Sequoyah Nuclear Plant (SQN)  
Responses to NRC Request for Additional Information  
(RAI) Regarding License Amendment Request (LAR) for  
Hydrological Analysis Update

July 16, 2020

# TVA Response to NRC Question 1.1

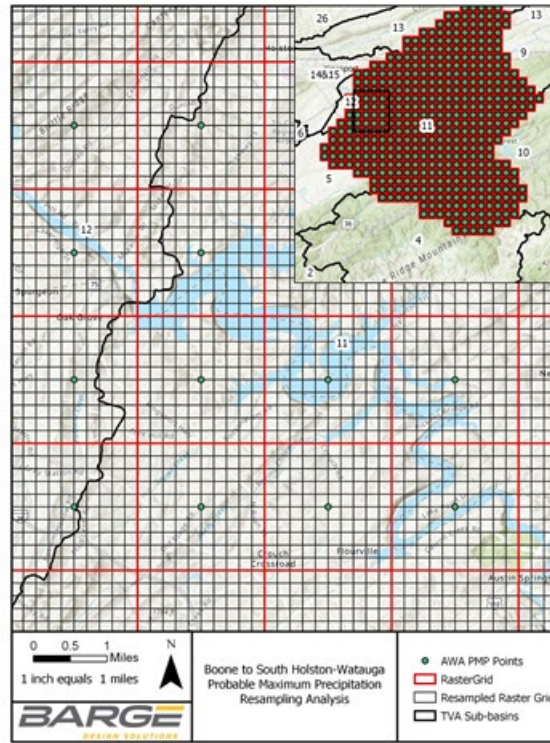
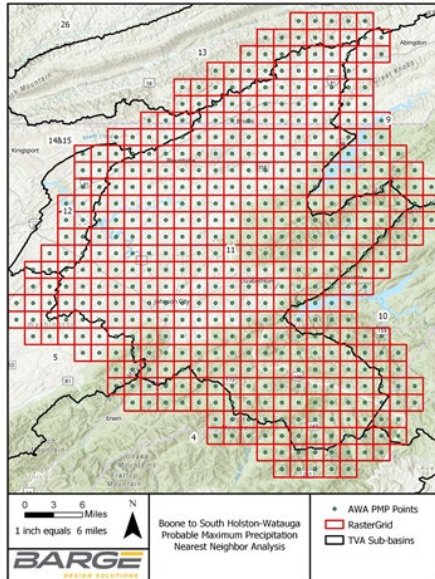
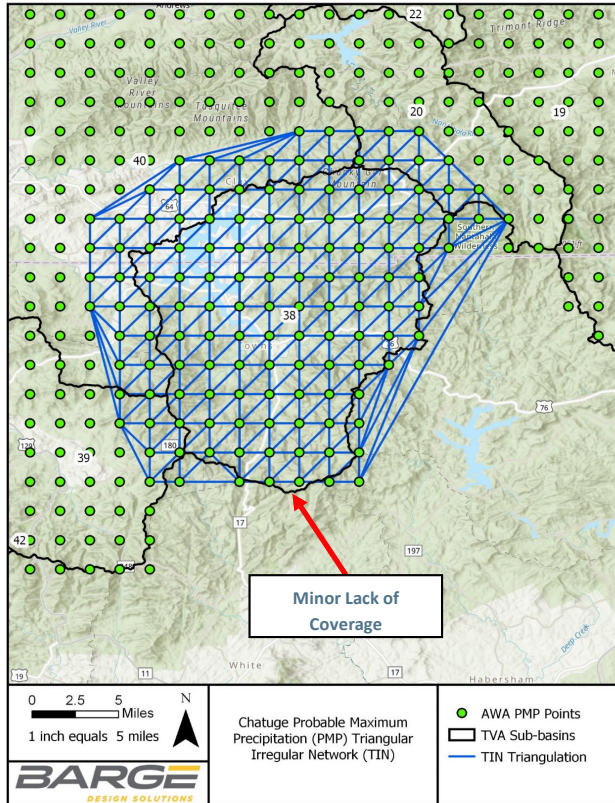
“TVA stated that the ArcGIS software uses gridded shapefile data to create a Triangular Irregular Network (TIN) surface that is used via a polygon volume tool to compute the sub-basin average Probable Maximum Precipitation (PMP) depths. In contrast, the QGIS alternate methodology utilizes the nearest neighbor geoprocessing tool to generate a raster surface that then uses a grid statistics tool to generate the nearest neighbor geoprocessing tool. It is unclear what the technical difference is between methodologies used to create a TIN surface and a raster surface and between the polygon volume tool and nearest neighbor geoprocessing tool used to create the sub-basin average PMP depths. **Therefore, the NRC staff requests TVA to clarify how these two methodologies are technically different such that the use of these alternate calculation methodologies can be credited to prevent the same erroneous outputs in both GIS tools.**”

## QGIS Methodology

- PMP Evaluation Tool depths used to create Raster through QGIS Nearest Neighbor tool.
- Only grid cells with centroid in basin utilized.
- Improved accuracy by bilinear interpolation by resampling tool
- **Average basin precipitation depth**= sum of cell volumes divided by area of basin boundary

- Triangulation vs Bilinear interpolation
- Polygon volume vs Arithmetic averaging of grid cells

# TVA Response to NRC Question 1.2

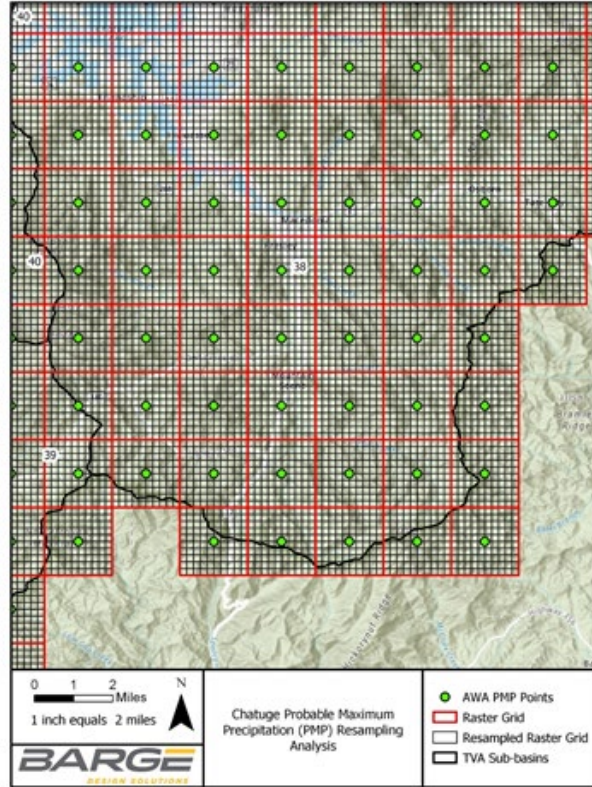
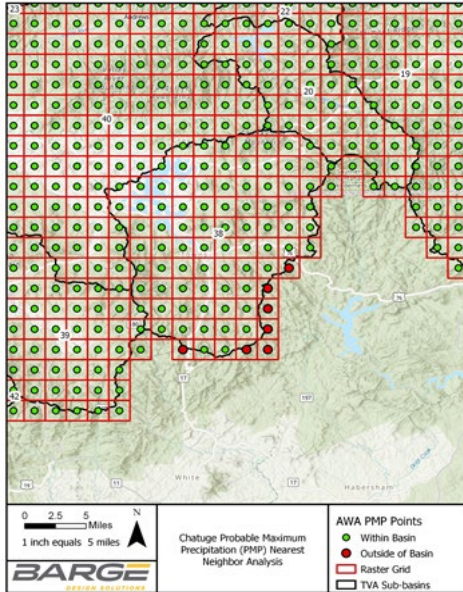
“In Enclosure 3, “Gridded PMP Development Calculation” of the RAI response, Appendix A “GIS PMP Event Depth Computations,” Section 6.5, states “Review of computed PMP depths across the ArcGIS and QGIS platforms identified a project PMP depth above Chatuge as an outlier. Analysis indicated areas around the sub-basin boundary with zero depth as the PMP points from the [Applied Weather Associates (AWA)] tool did not provide adequate coverage during TIN creation for the single sub-basin. PMP depths utilized for Chatuge are based on QGIS analysis to eliminate results without the complete PMP coverage.” Since QGIS is used to verify the results of ArcGIS and their results are dissimilar for Chatuge, it is not clear what the basis is for using the output of QGIS instead of ArcGIS for this area. In addition, since the TVA determined that ArcGIS did not provide adequate coverage for Chutage, it is not clear how the output of QGIS is determined to be correct for this area. **Therefore, the NRC staff requests TVA to justify the use of the QGIS output for the Chatuge sub-basin.**”

- Alternate calculation check of ArcGIS calculations in QGIS led to additional review of results
- Review showed Triangulation in ArcGIS had an area of 0.88 square-miles less than QGIS, equating to less than 0.5% of the total 189.1-sq.-mi. Chatuge basin area without TIN coverage
- The alternate calculation check in QGIS via the alternate methodology ensures full coverage of PMP depth data points over the basin by use of the QGIS resample tool to provide a grid of PMP depths at a 0.0025 by 0.0025 decimal degree grid

- Over 2,500 individual PMP surfaces were checked in QGIS with only those surfaces associated with a Chatuge PMP resulting in differences greater than 0.6% for the Chatuge sub-basin average.
- Application of the adjacent grid point depths to the small uncovered area by the ArcGIS method result would approximate the QGIS result, providing the alternate calculation comparison and justification of the QGIS result for the Chatuge basin
